RE: July 28th PC meeting subject: Sherwin Williams Development Project.

From: John Scheuerman <streetcars4us@att.net>
Sent: Monday, July 25, 2016 8:38 PM
To: Planning Commission; Nora Davis; Ruth Atkin; Jacqueline Asher; Scott Donahue; Dianne Martinez
Cc: Charles Bryant; josh@craig-communications.com
Subject: Lessons Learned and Suggestions for Sherwin-Williams
Attachments: Observations and Lessons Learned for Sherwin-Williams 25Jul2016.pdf

Subject: Sherwin Williams Draft EIR and Study Session.

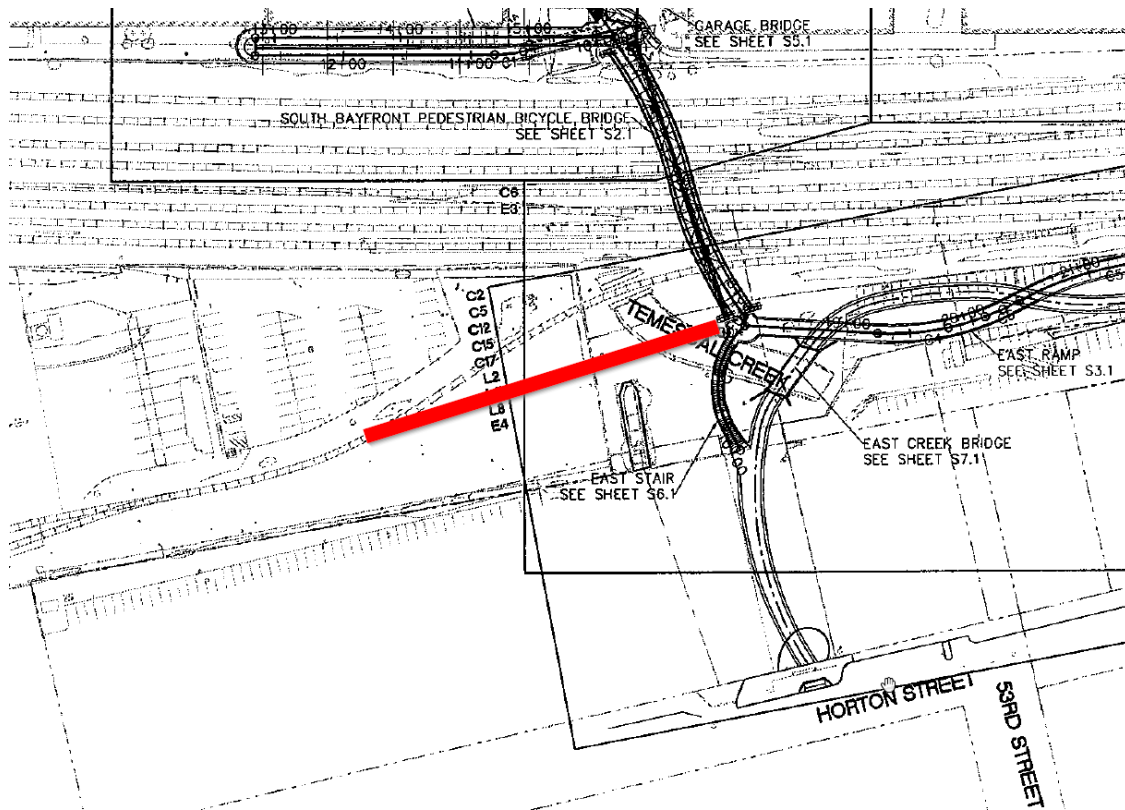
The current proposal will create an isolated neighborhood that is similar in character to a typical suburban apartment complex. Given the isolation, the retail/commercial spaces that can bring life to this area stand little chance of success. But by applying the lessons learned, we can create a vibrant, inviting, and connected neighborhood that will significantly improve transit access to the Bay Street Center.

1. The current plan ignores the new bike/pedestrian bridge. This **vital transit link** between Sherwin-Williams and Bay Street needs to be celebrated and to become the focus of the project. It provides the opportunity to establish the **critical mass of people** to add vibrancy to the neighborhood. Parking at Bay Street can serve both Bay Street and commercial/retail spaces at Sherwin-Williams.

- Incorporate a ramp from the new South Bayfront Bridge that ties directly to a high quality transit stop. This may be an Emery Go-Round stop in the near term and a streetcar stop in the long term. **Keep in mind that pedestrians want a straight line route that provides clear visibility of the overall walking path.** The conceptual design of this bridge was intended to provide the ability to add a southbound ramp when the Sherwin-Williams site is developed. Similar to New York's Highline and Boston's Greenway, this extension of Emeryville's greenway functions as **both park and pedestrian corridor**.

Monterey & Hopkins – Neighborhood centers offering a variety of goods and services occurred naturally at streetcar stops of the past.

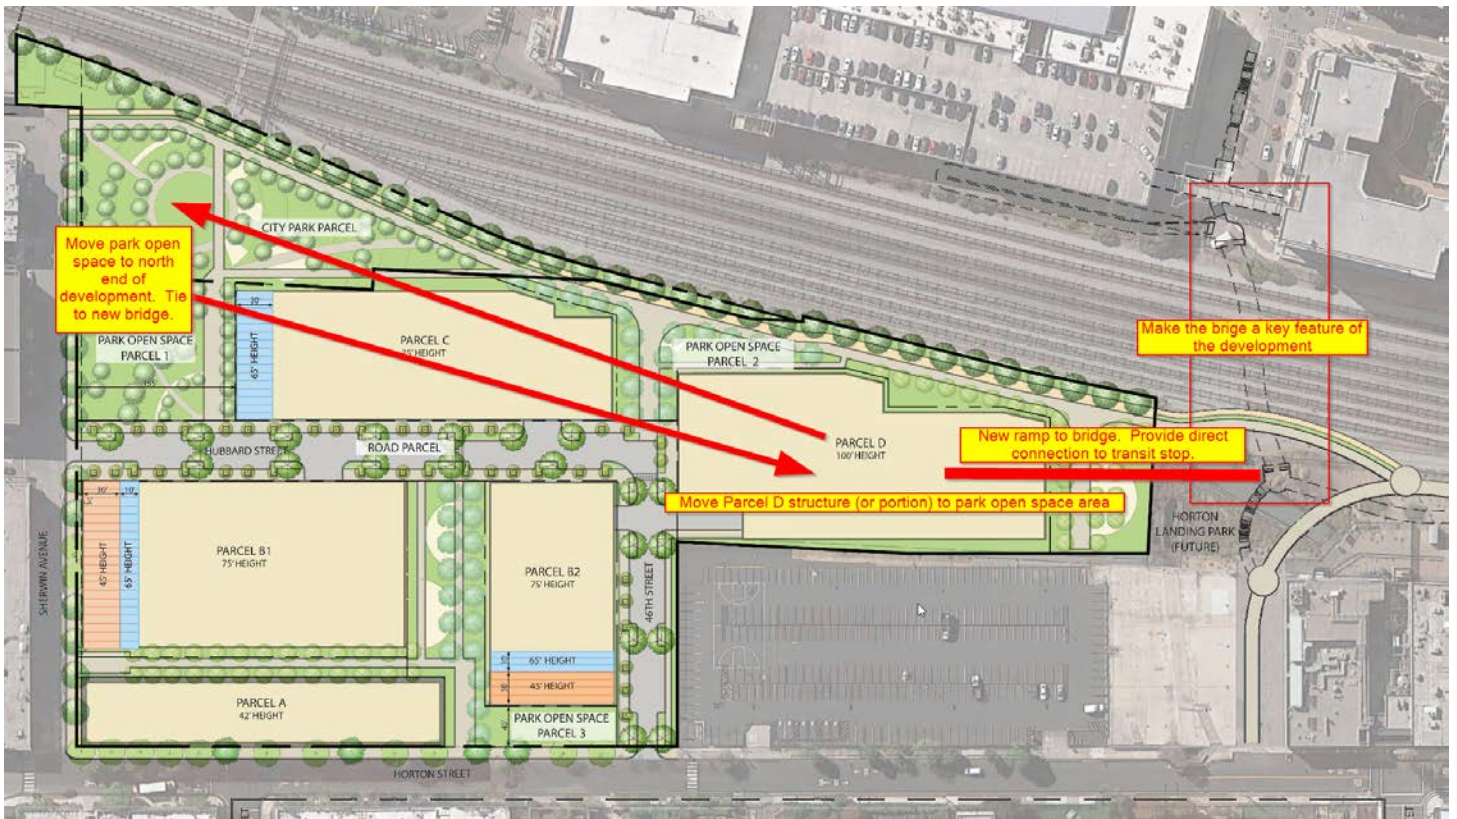
- Put a streetcar stop where commercial / retail development is desired and design ground floor building spaces for flexible uses. Transit passengers going to/from Bay Street will patronize businesses at Sherwin-Williams.
